**TOWN OF NEWBURGH
PLANNING BOARD
TECHNICAL REVIEW COMMENTS**

PROJECT NAME: NEWBURGH SELF STORAGE-1420 ROUTE 300
PROJECT NO.: 24-6
PROJECT LOCATION: SECTION 60, BLOCK 3, LOT 22.222/1420 Route 300
REVIEW DATE: 28 AUGUST 2024
MEETING DATE: 5 SEPTEMBER 2024
PROJECT REPRESENTATIVE: COLLIERS ENGINEERING/JUSTIN DATES, RLA

Newburgh Self-Storage - 1420 Route 300

Below please find our responses to comments received from MHE Engineering dated June 14, 2024. The comments have been repeated here for clarity:

BUILDING ELEVATIONS

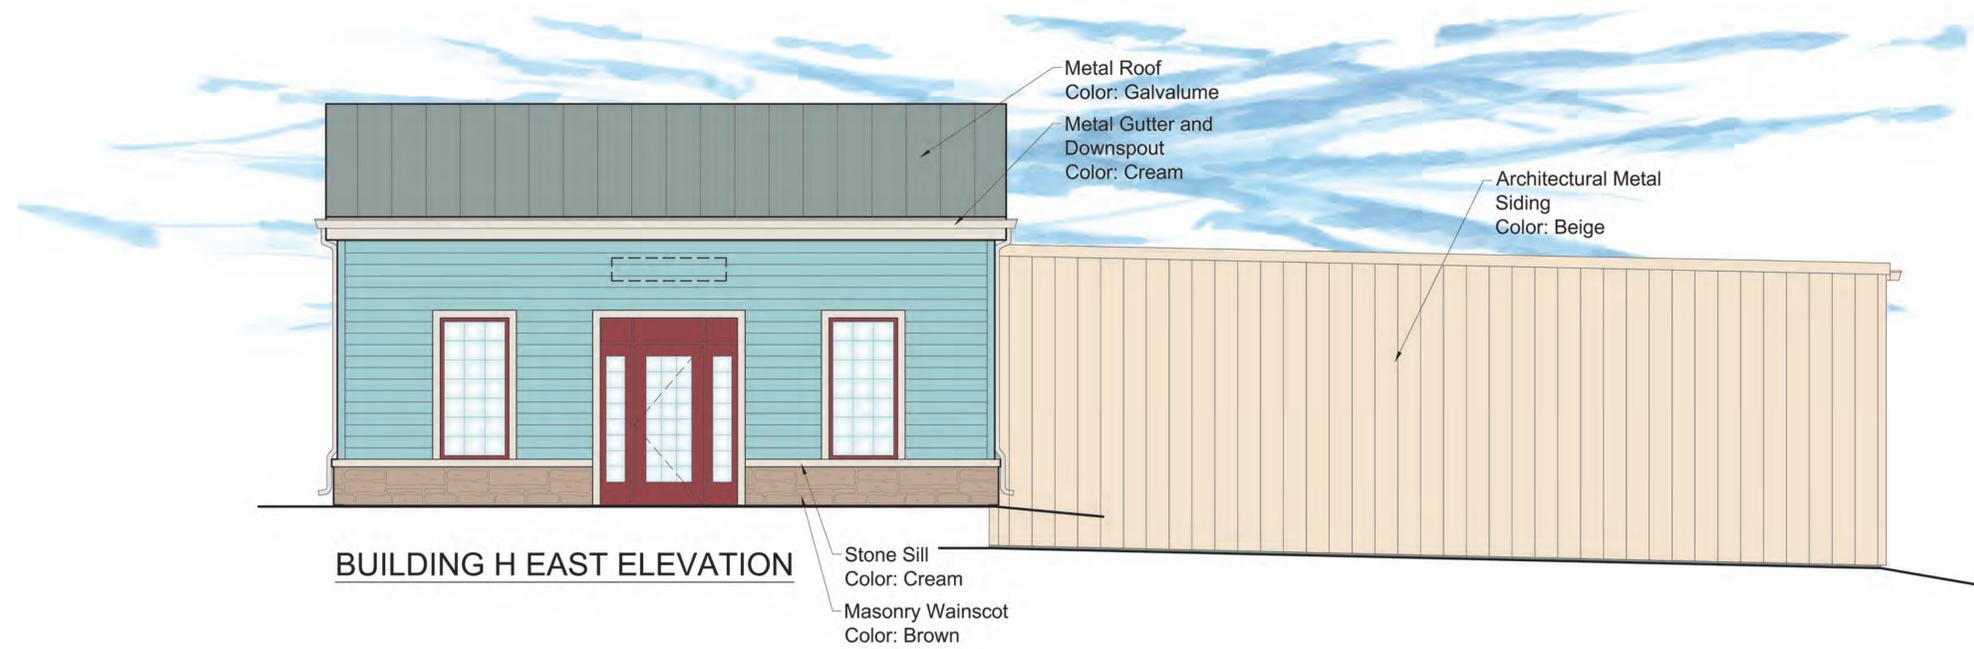
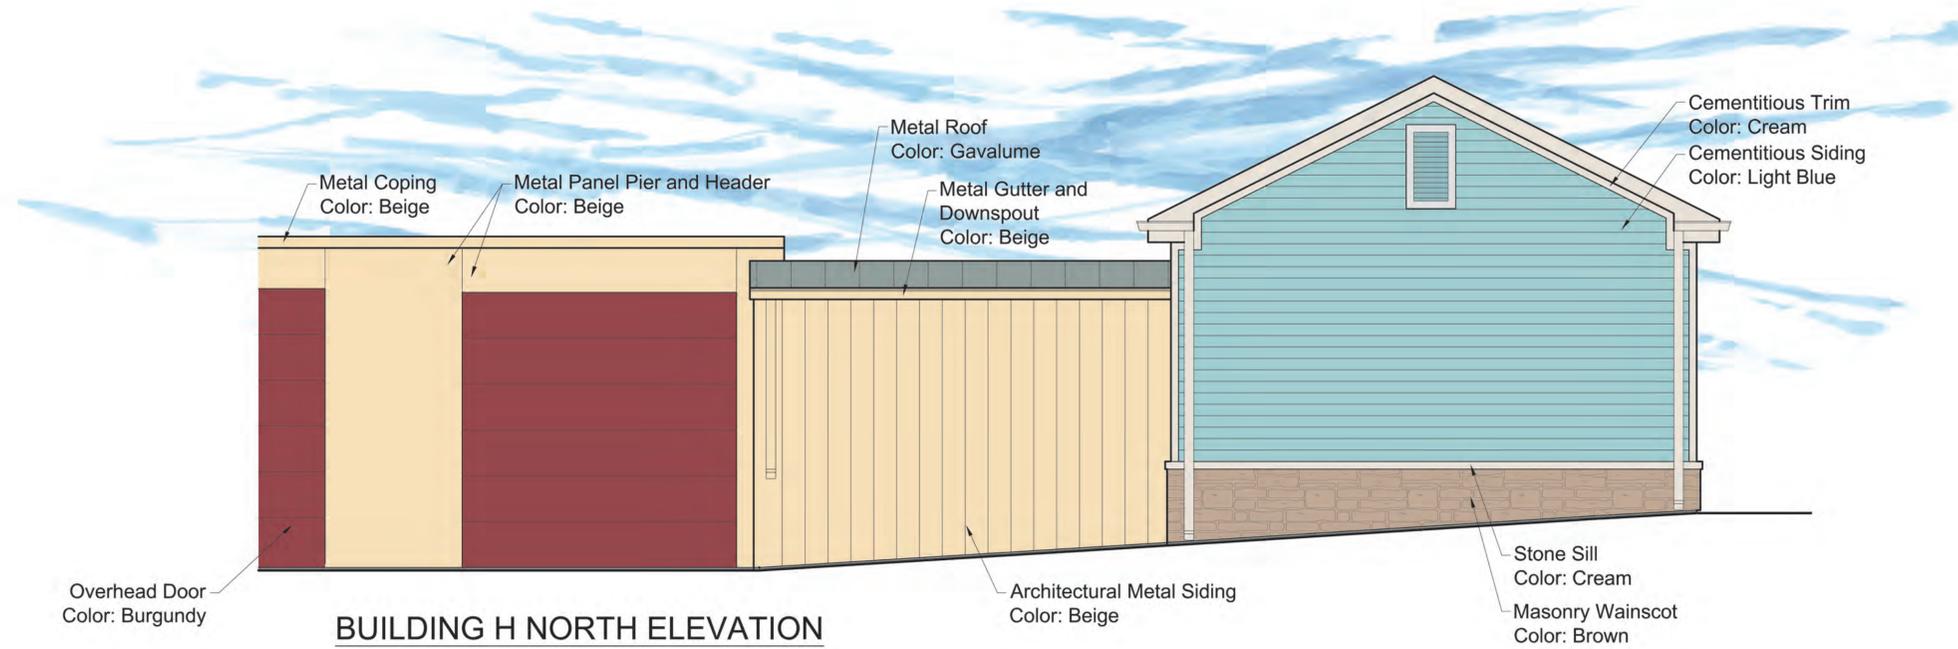
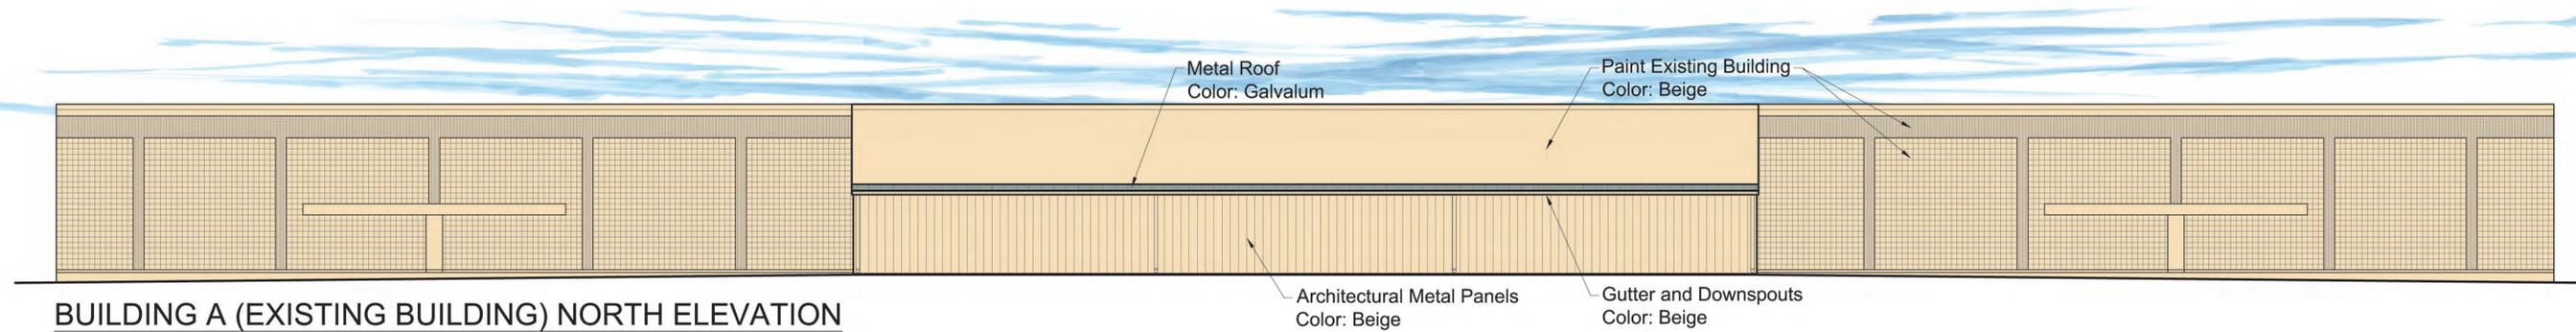
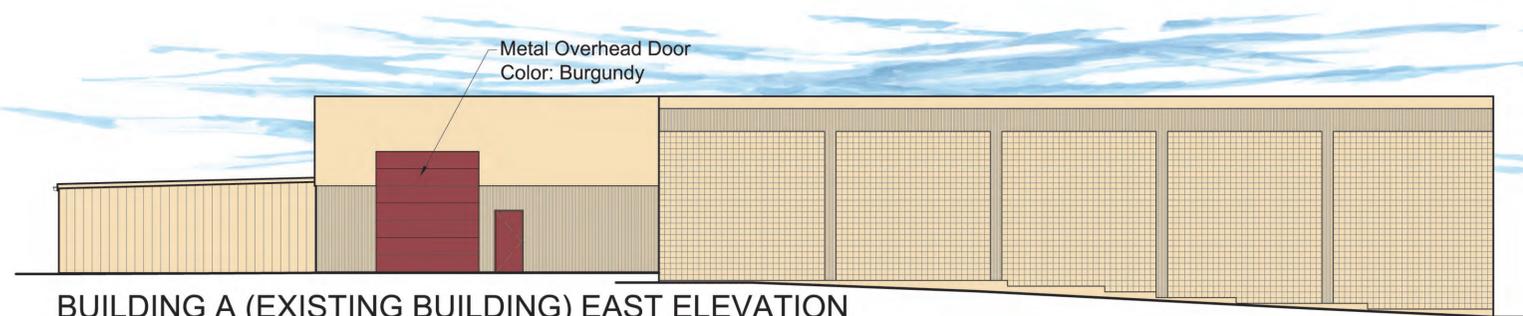
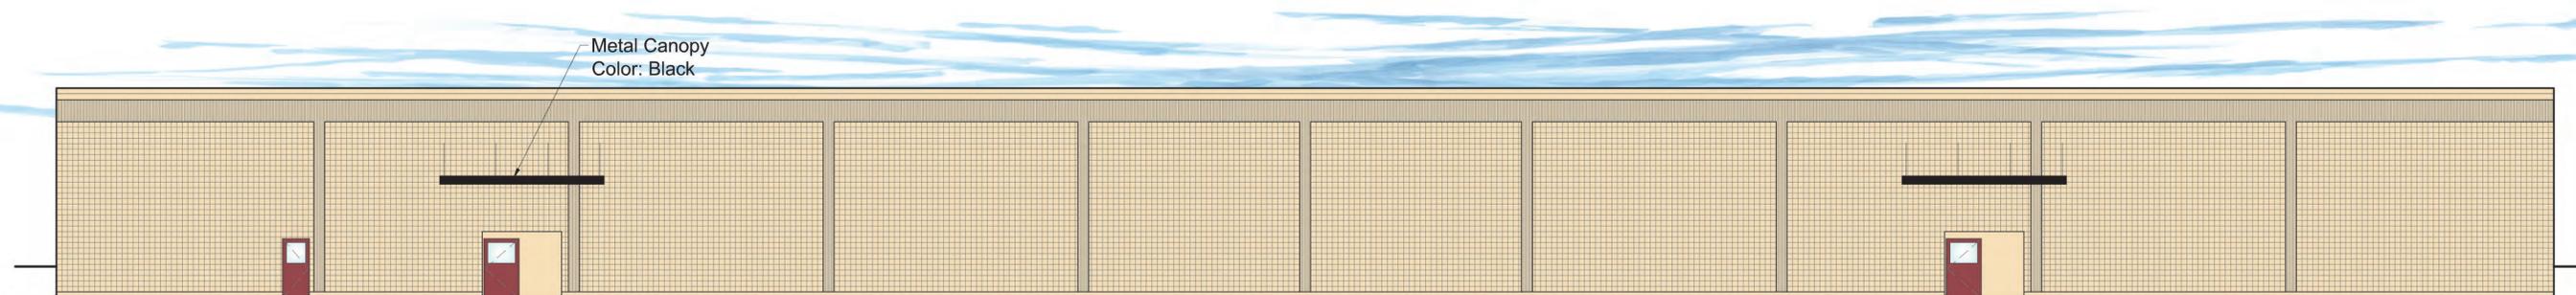
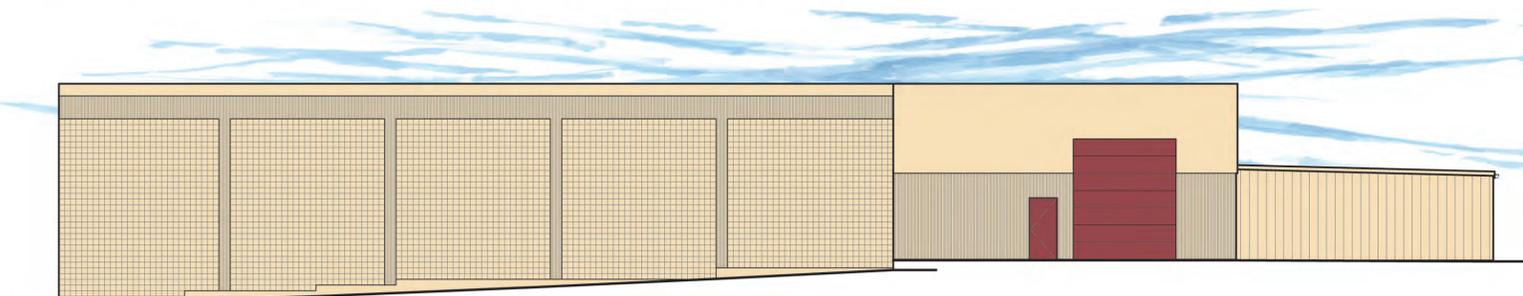
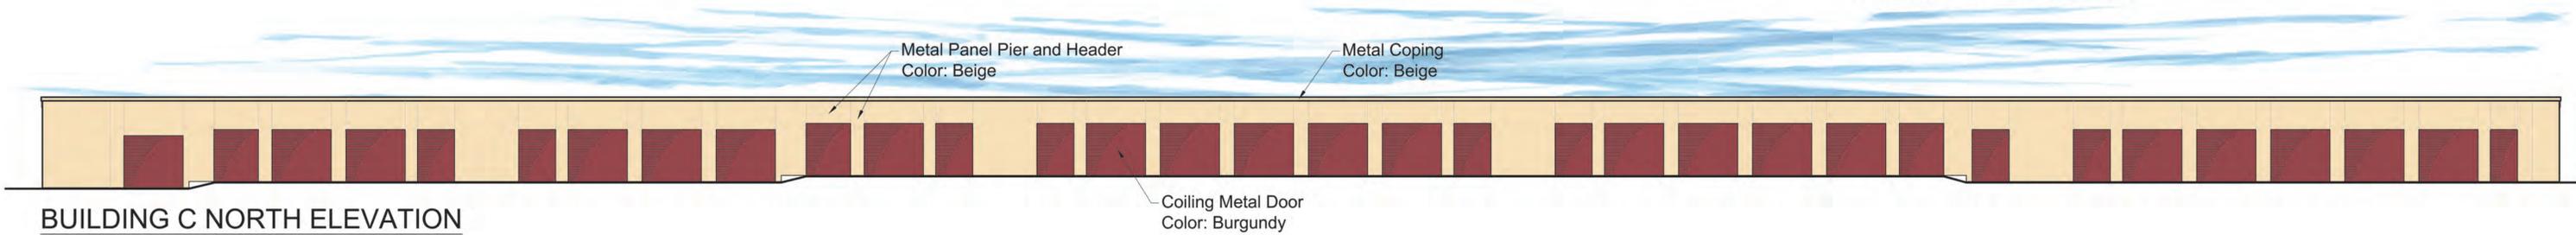
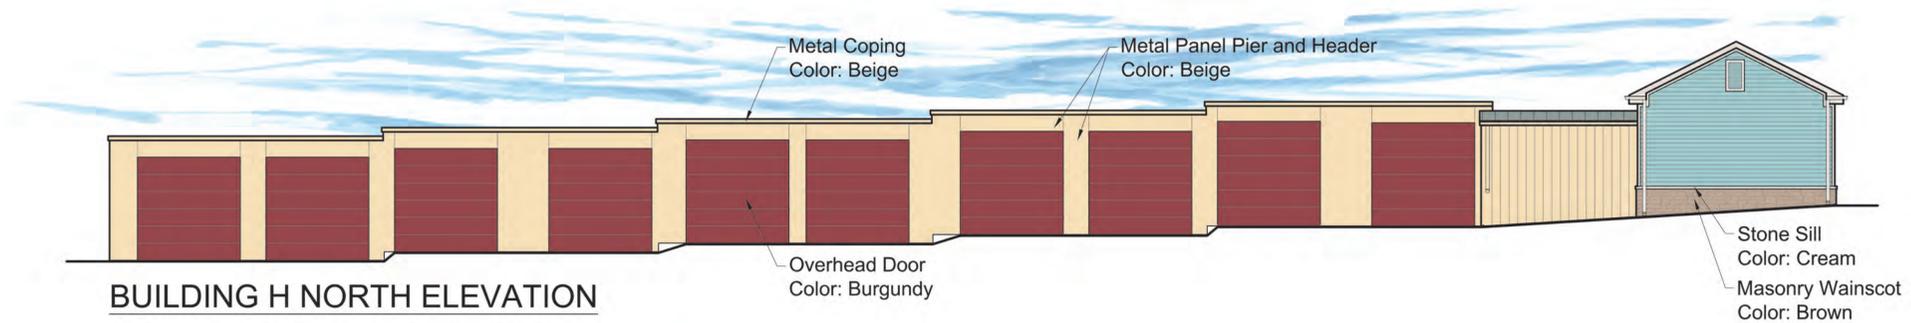
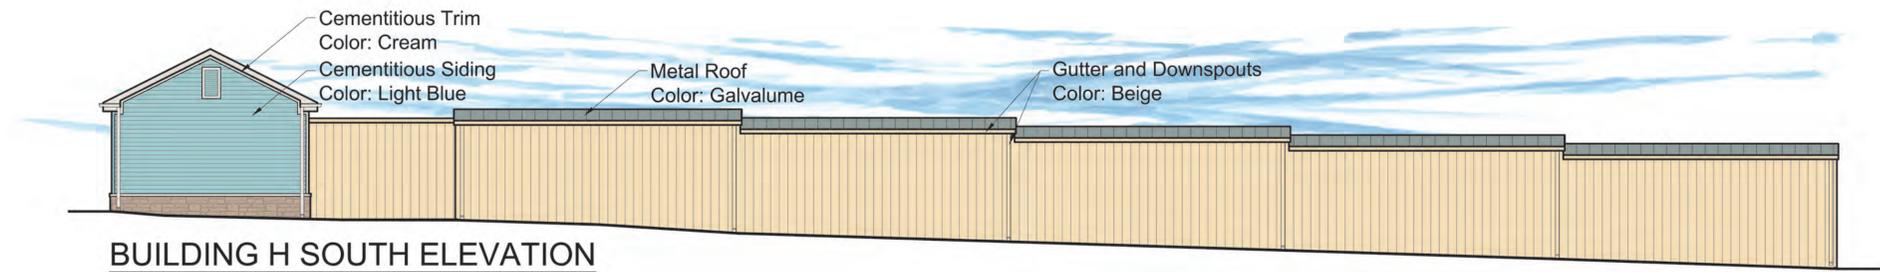
Comment 7: The project is subject to architectural review by the Planning Board. Future architectural submissions are identified as to provided.

Response 7: Attached with this submission, please find rendered, Architectural Elevations for the project & an updated Architectural Review Form. The applicant will present these items to the Board at the next meeting.

SHEET NUMBER: C-3.0

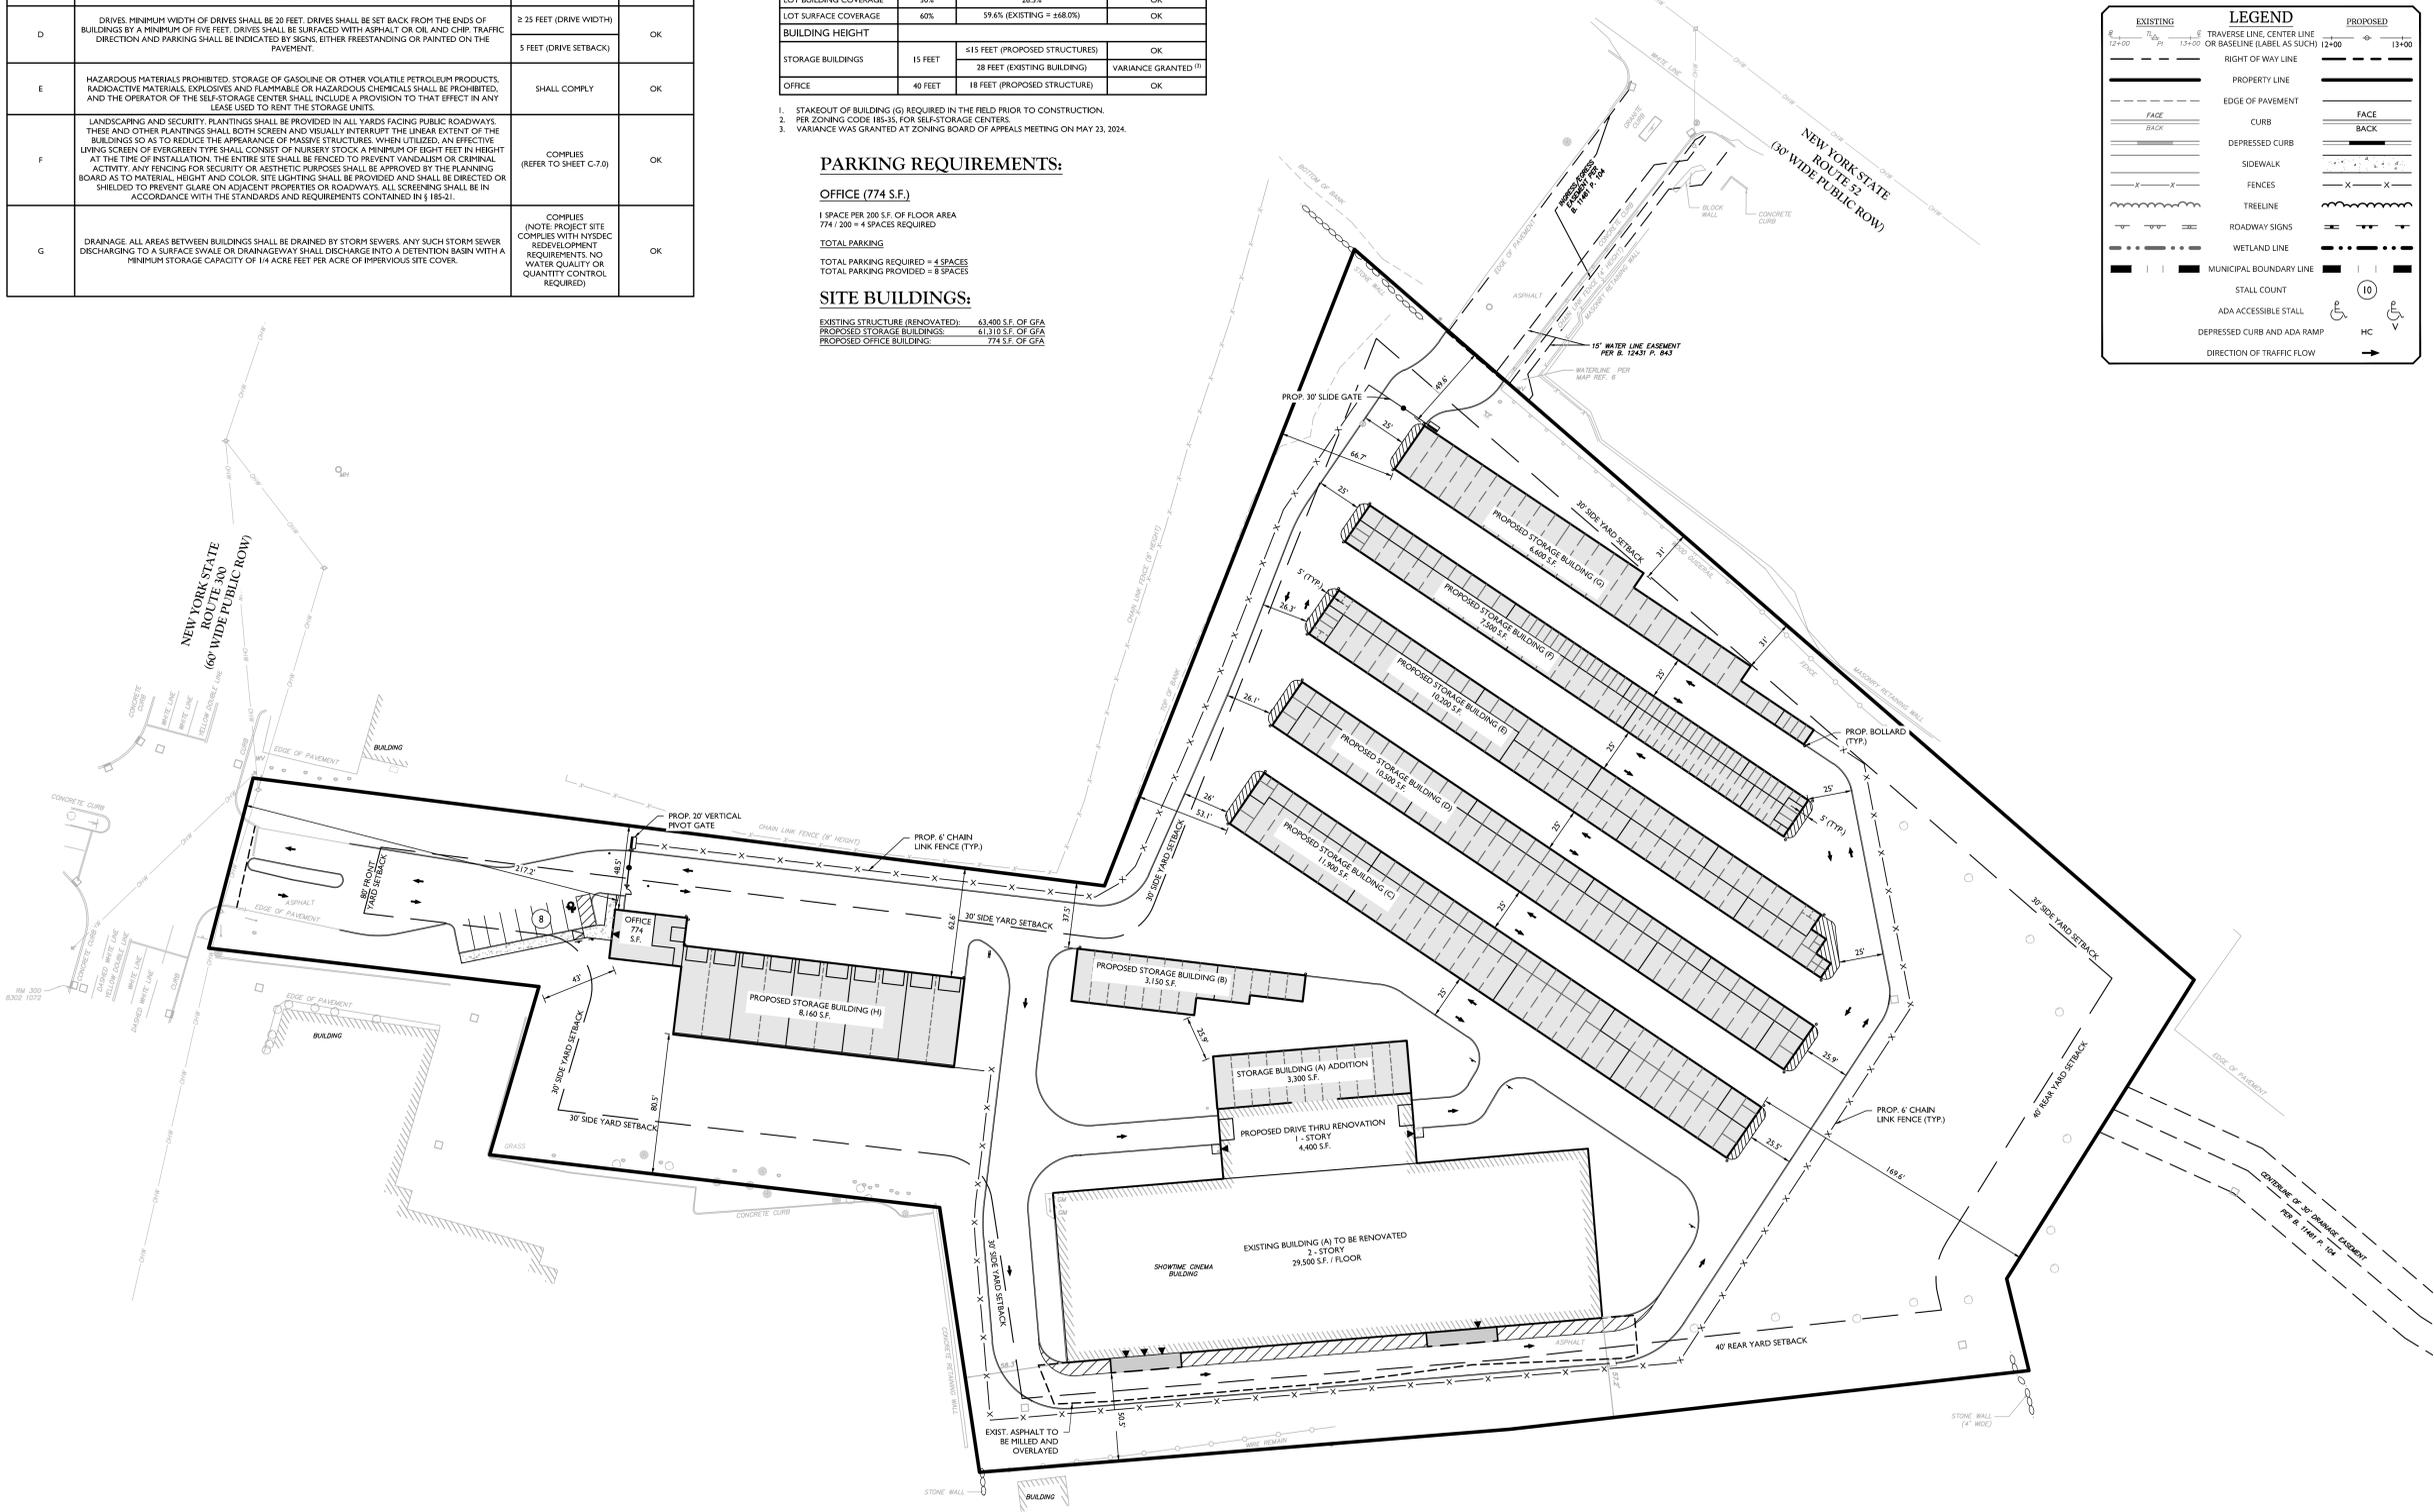
Comment 6: The northerly most structure on the site, a 6,600 square foot storage building continues to be located 1 foot off the side yard setback. Note requiring stakeout of that structure in the field prior to construction should be placed on the plans.

Comment 8: All sections of 185-35 Self Storage Centers A thru G should be specifically addressed.

Comment 9: Dimensions between buildings should be labeled to assure 25 foot separation between buildings exists.

Response 6: As requested, the above note requiring stakeout has been added to the bulk table on the Overall Dimension Plan on Sheet C-3.0.

Response 8: As requested, a table identifying the Self-Storage Center requirements from §185-35 has been added to the Overall Dimension Plan on Sheet C-3.0.

Response 9: Additional dimensions between buildings have been added to the Dimension Plans to confirm compliance with the 25-foot minimum separation, see Sheets C-3.0 & C-3.1.
